1435 - P095

Bedroom//Existing///Plan_1:20

Rev	Date	Notes
A	23.06.15	Radiator added and joinery removed .

Bedroom//Proposed//Elevation 4_1:20

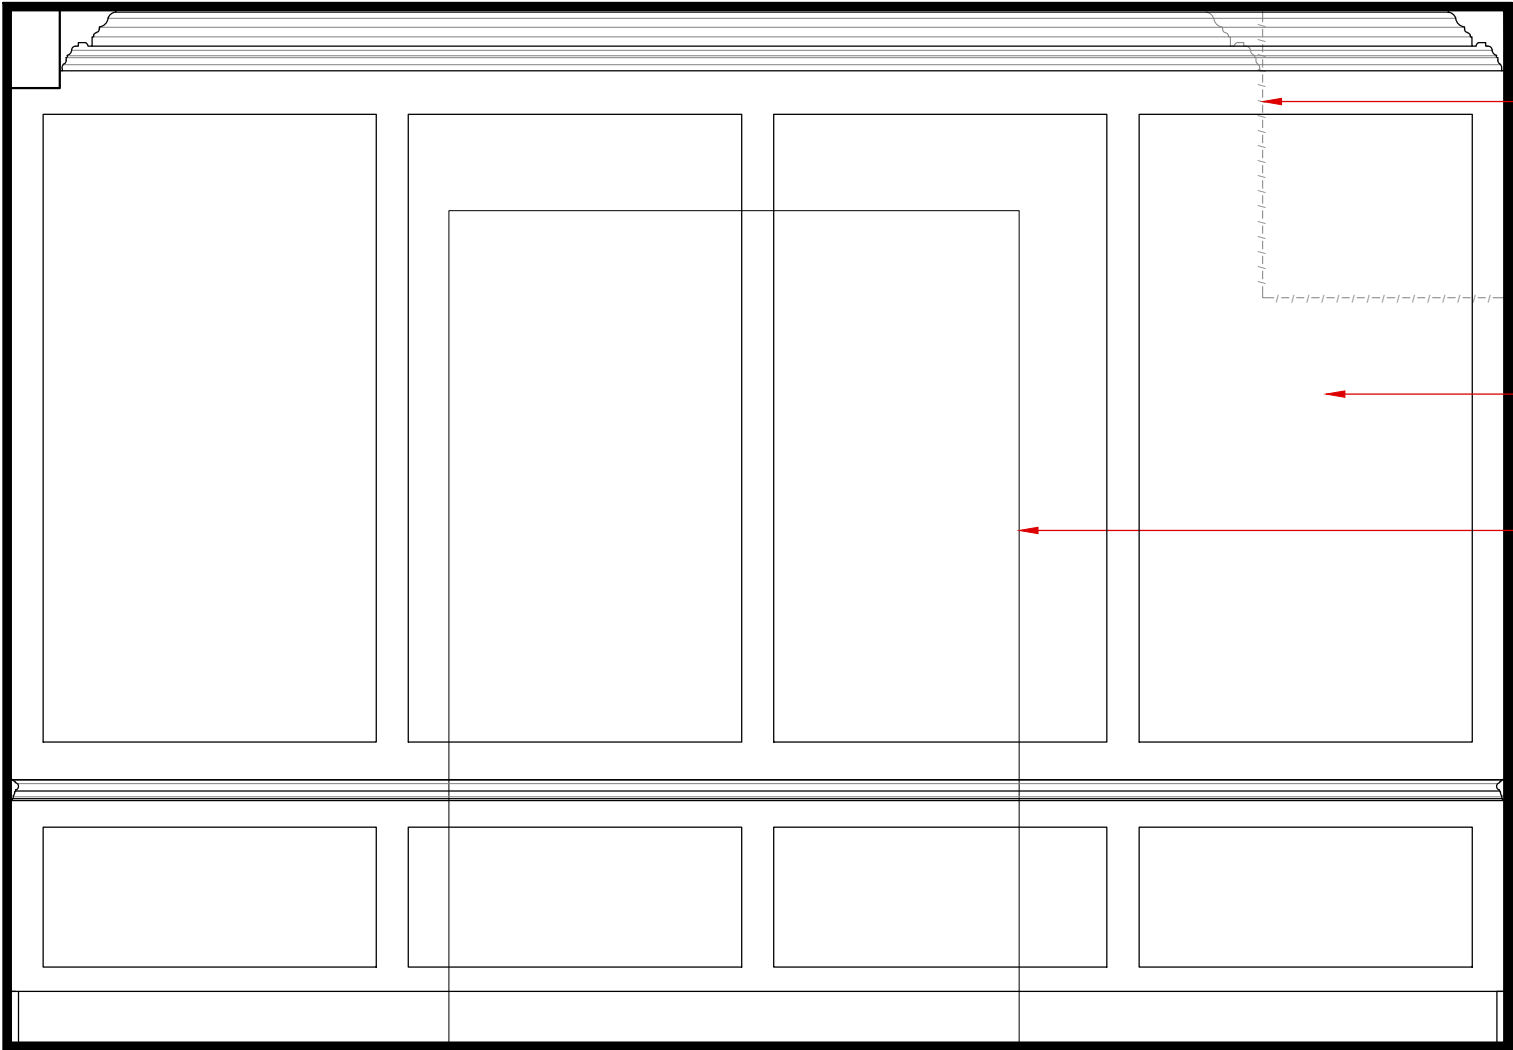
Existing fixed cupboards removed. Existing cornice reinstated to wall.

Proposed simple panelling to match elevation 3.

Proposed freestanding unit.

Rev	Date	Notes
A	23.06.15	Door removed between Bedroom and Dressing Room

Dressing Room//Existing//Elevation 2_1:20

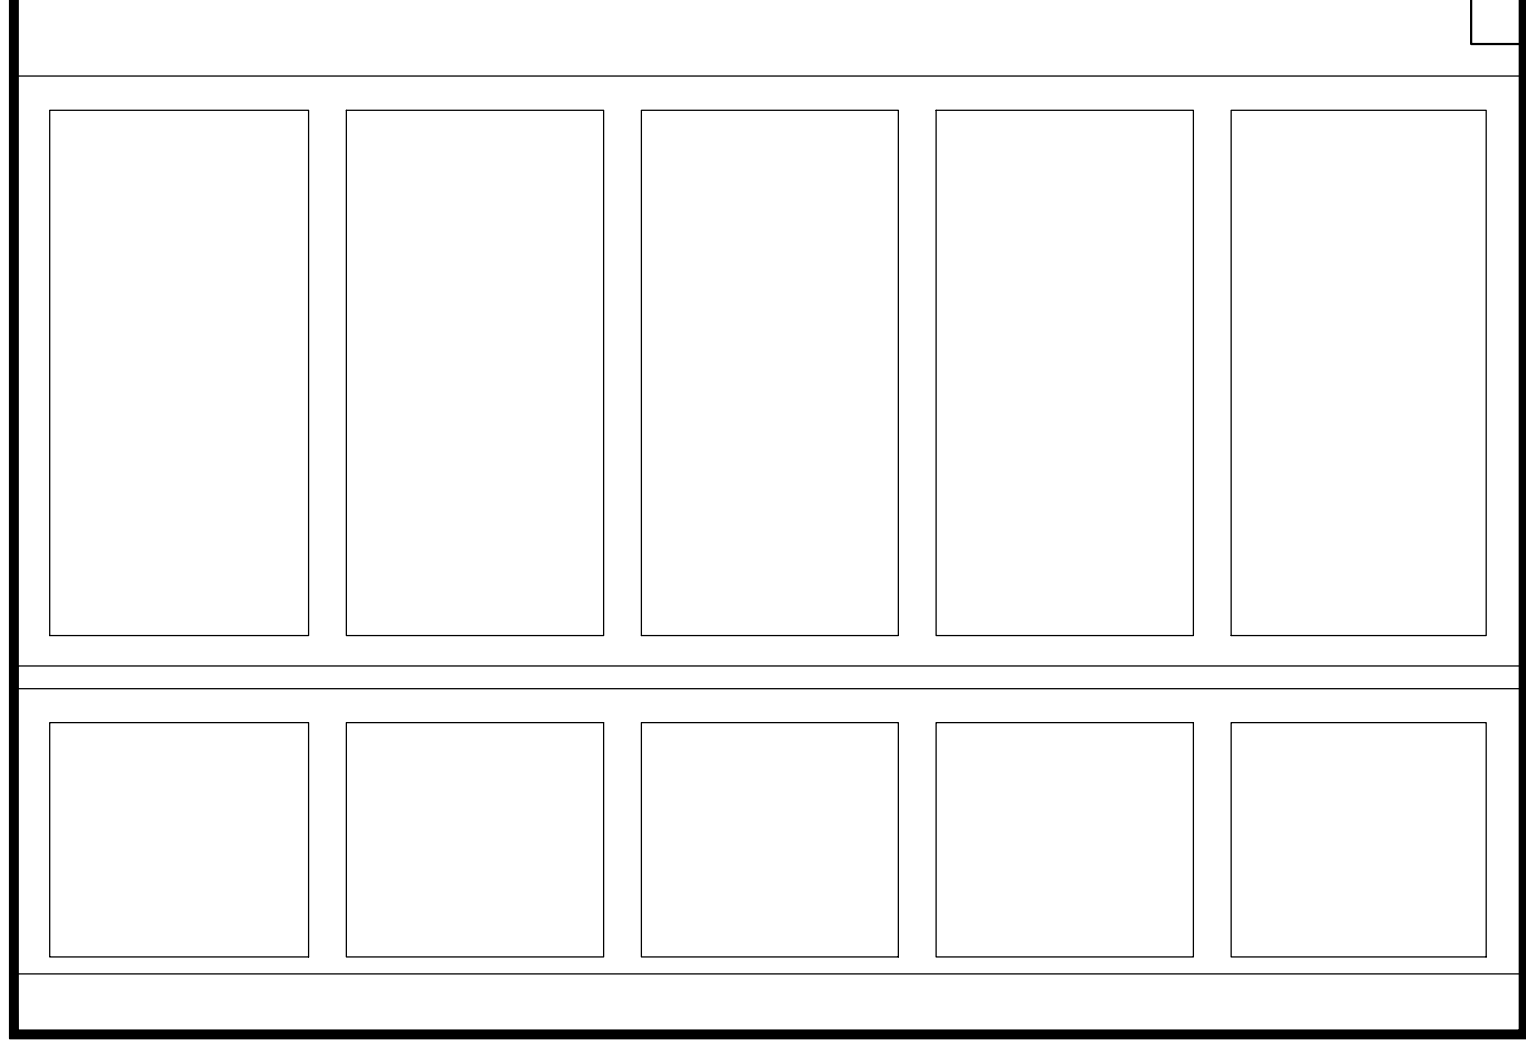
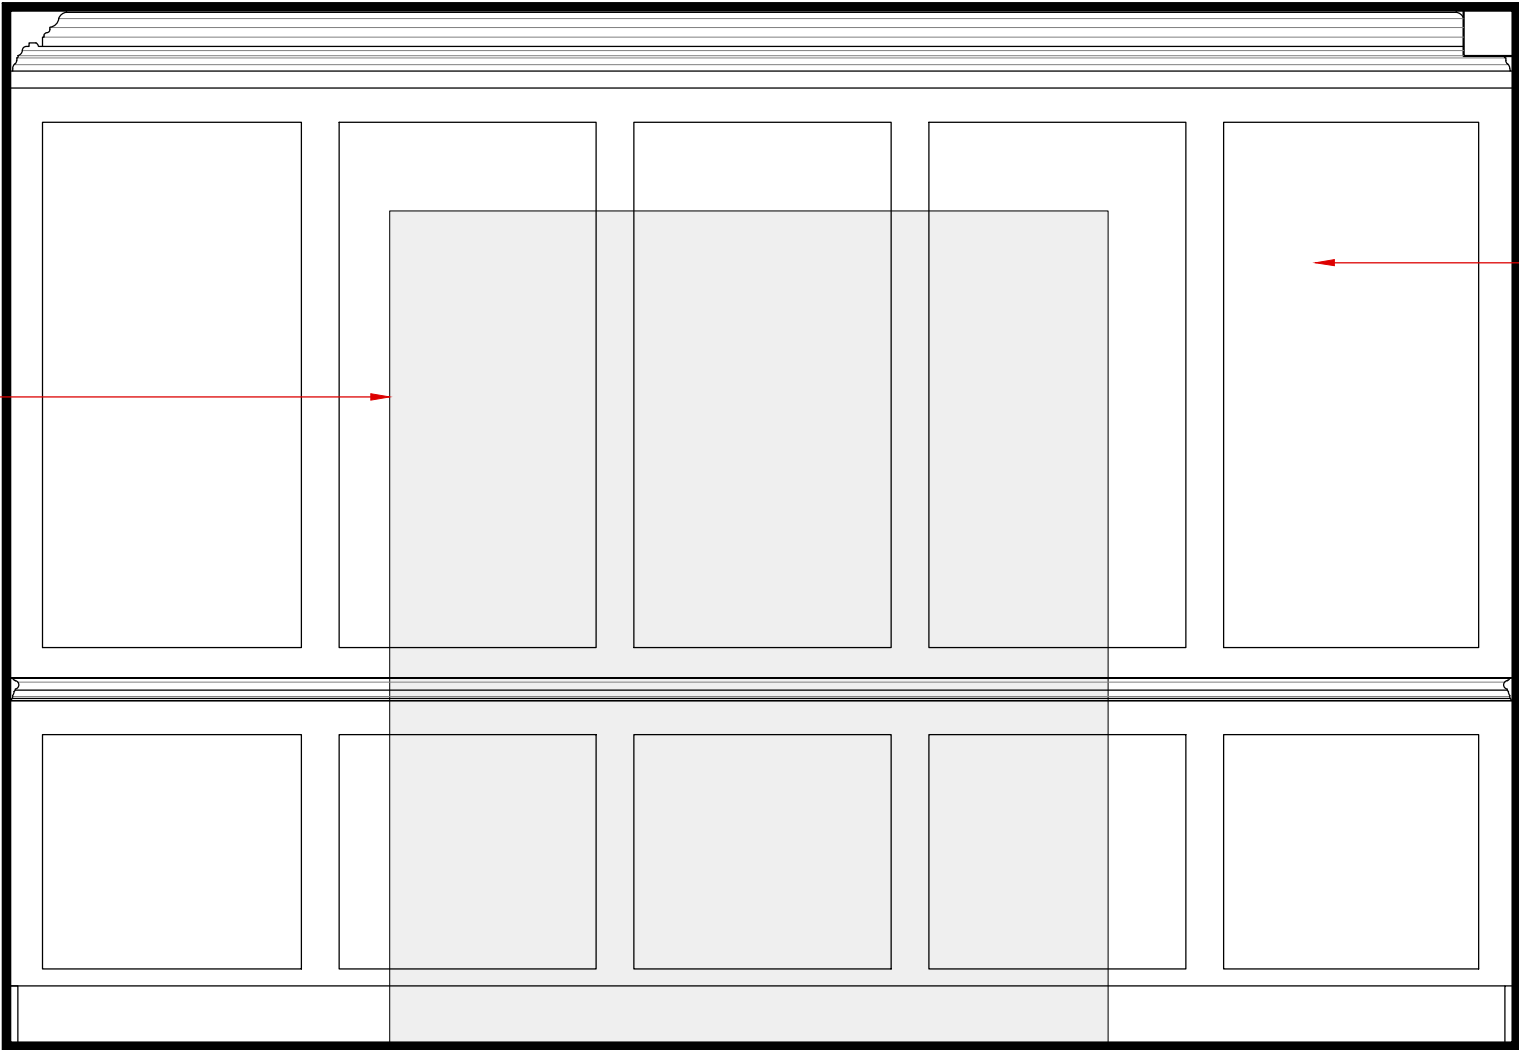
Proposed client supplied unit.

Existing panelling to be retained.

Rev	Date	Notes
A	23.06.15	Door between bedroom and dressing removed.

Dressing Room//Existing//Elevation 3_1:20

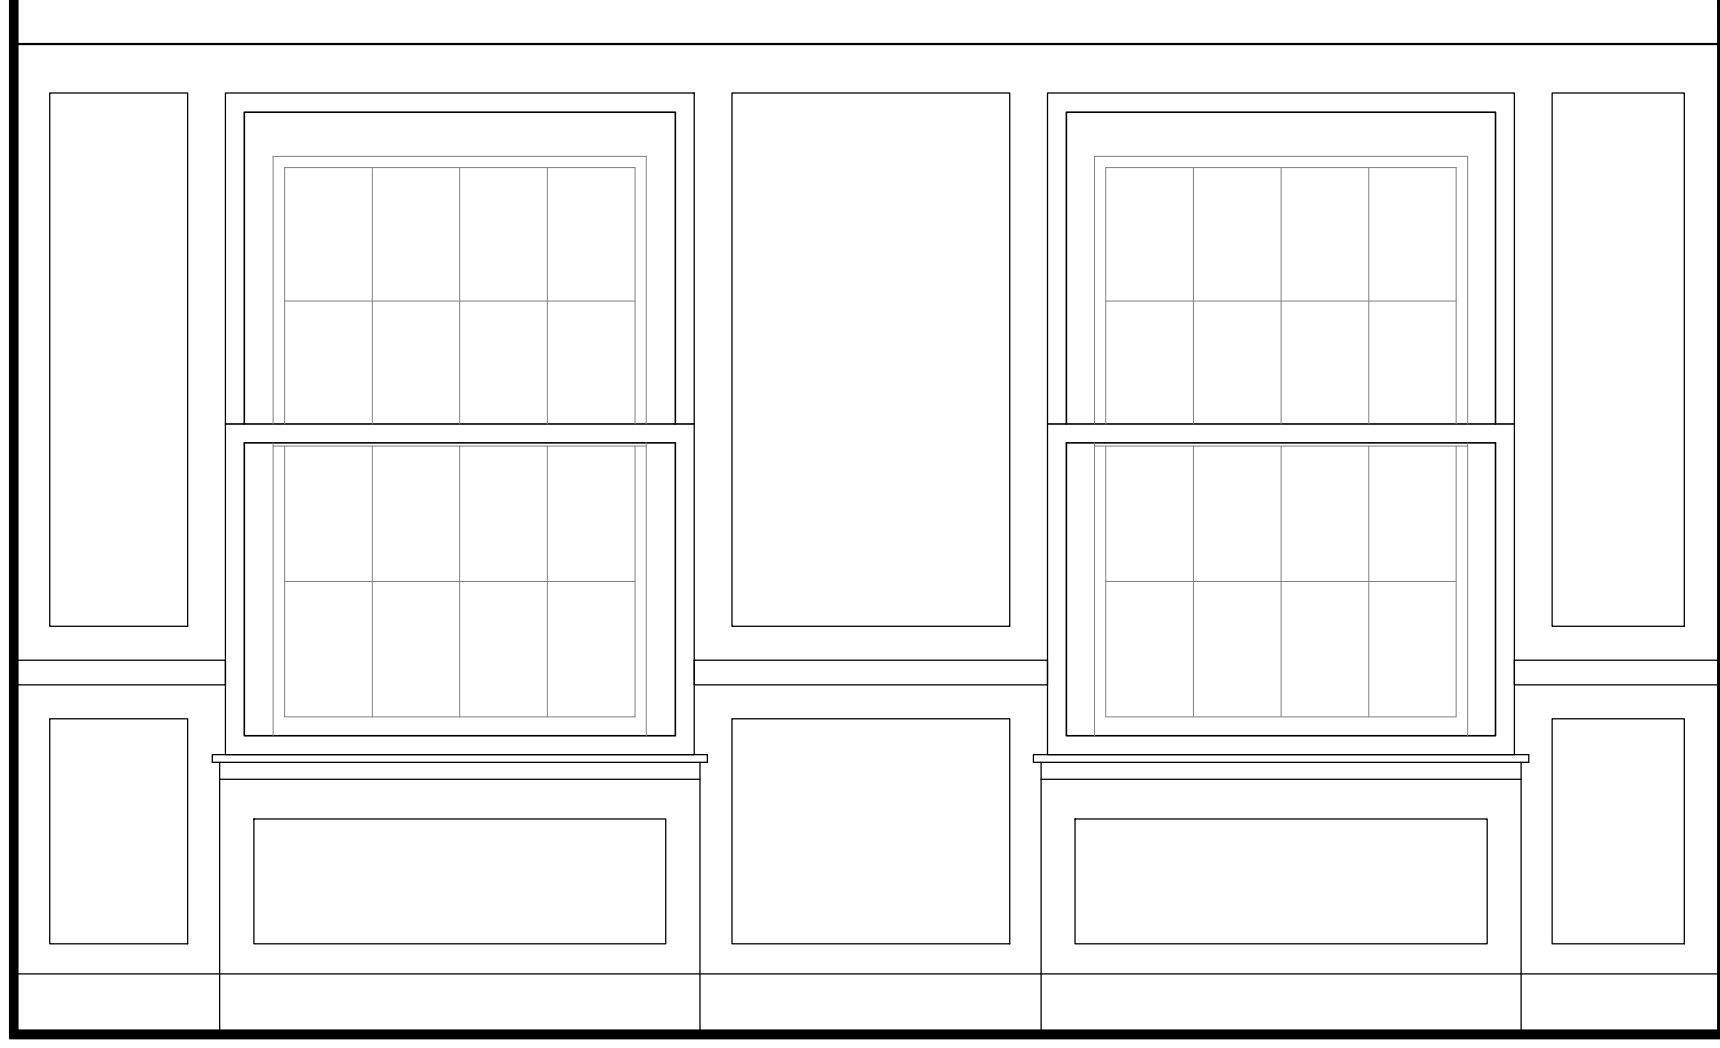
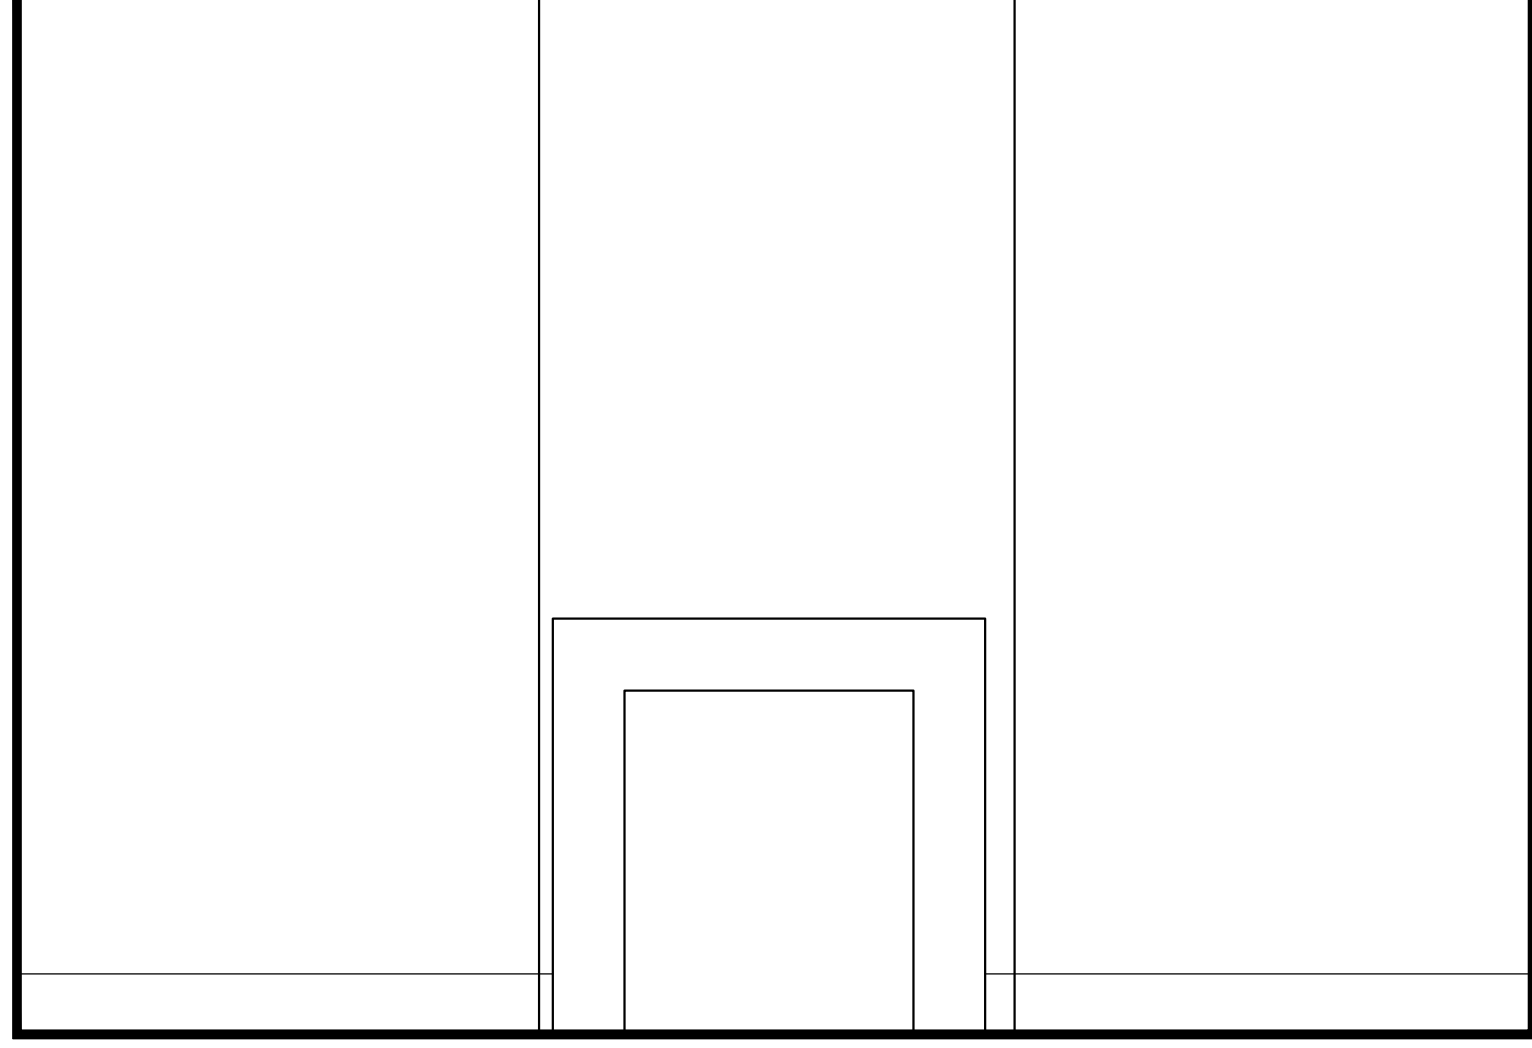
Existing secondary
glazing removed and
replaced with new.

Proposed free standing
unit

Rev	Date	Notes
A	23.06.15	Radiators added.

Master Bathroom//Existing//Elevation 1_1:20

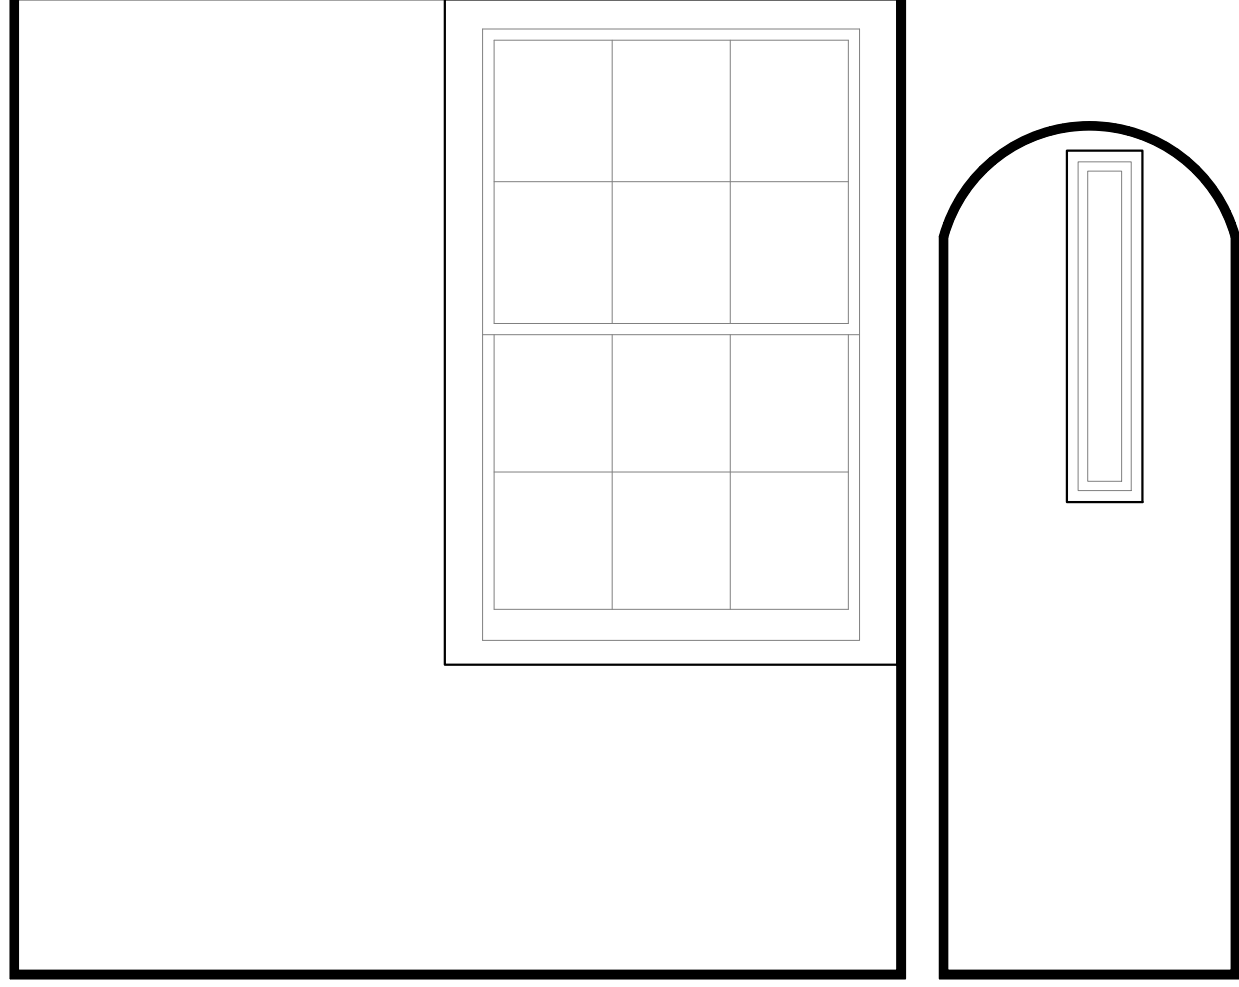
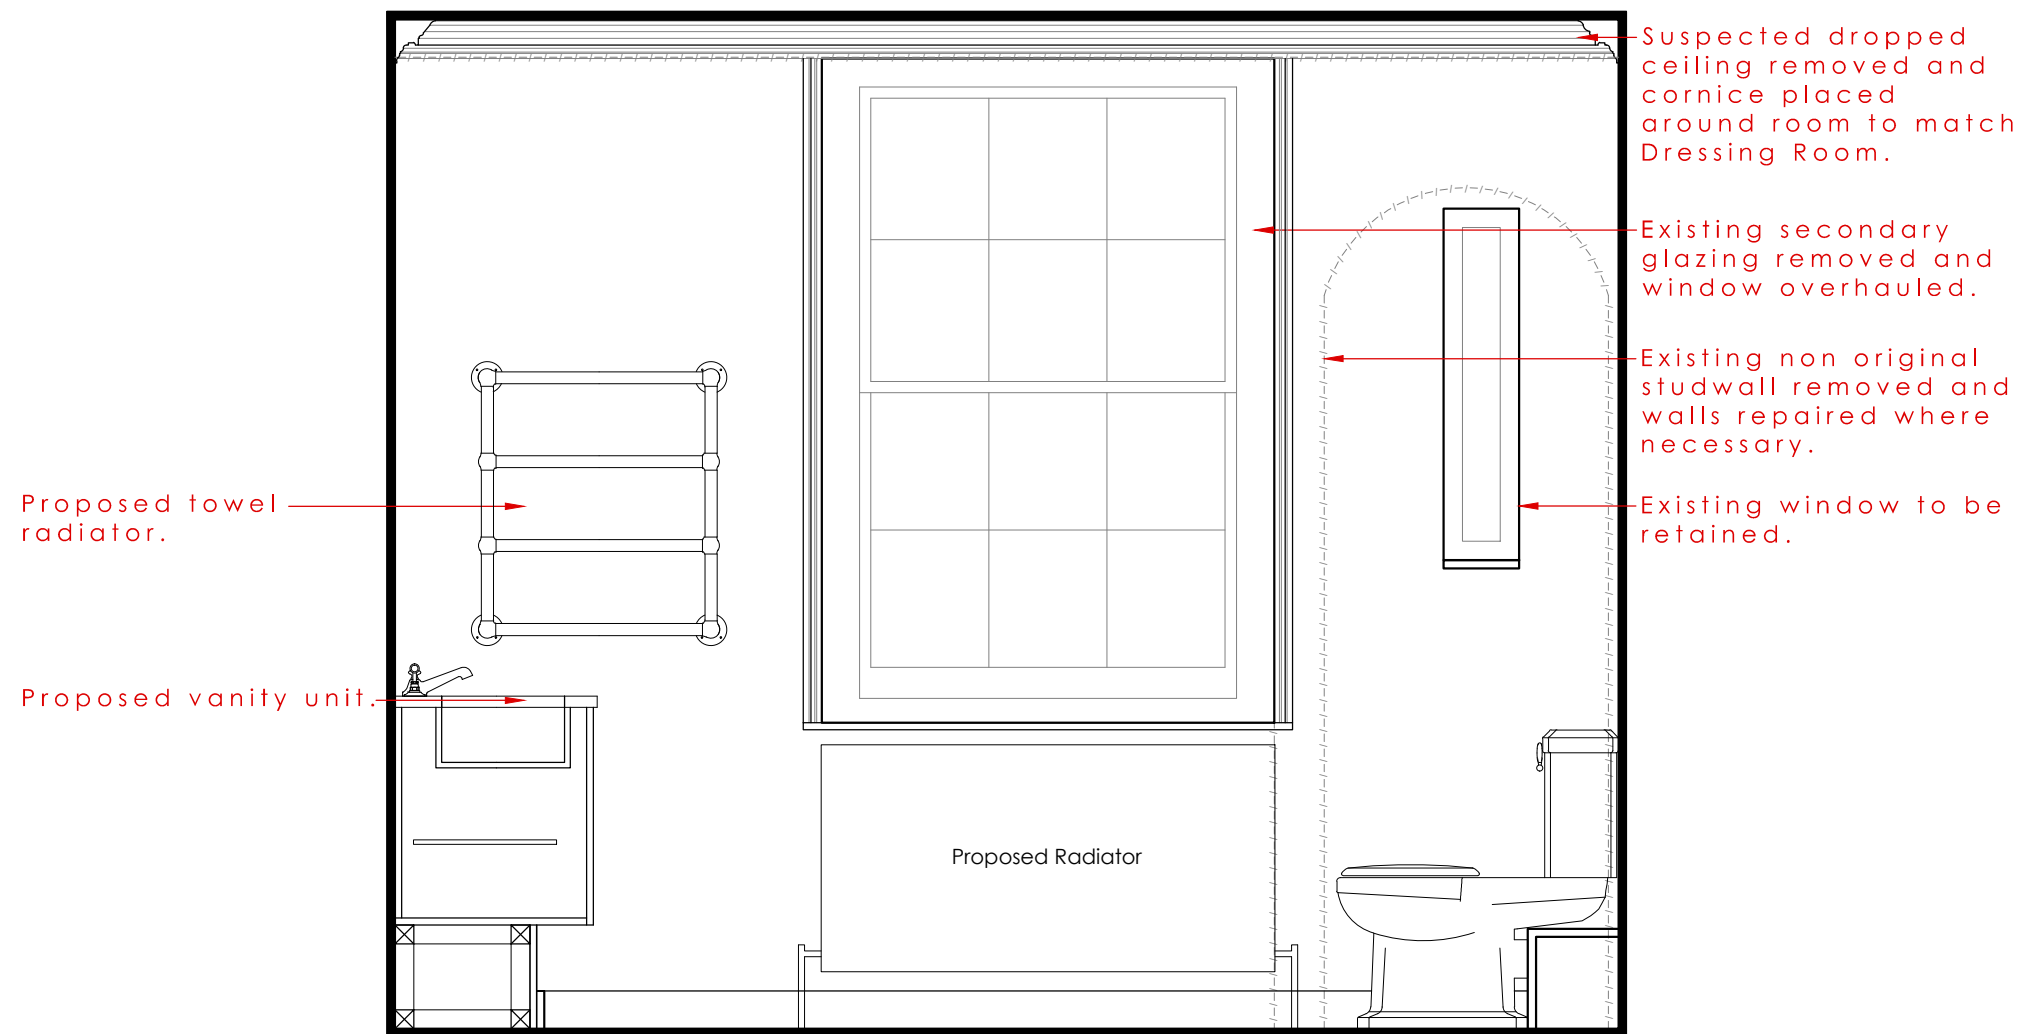
Rev	Date	Notes
A	23.06.15	Radiator added.
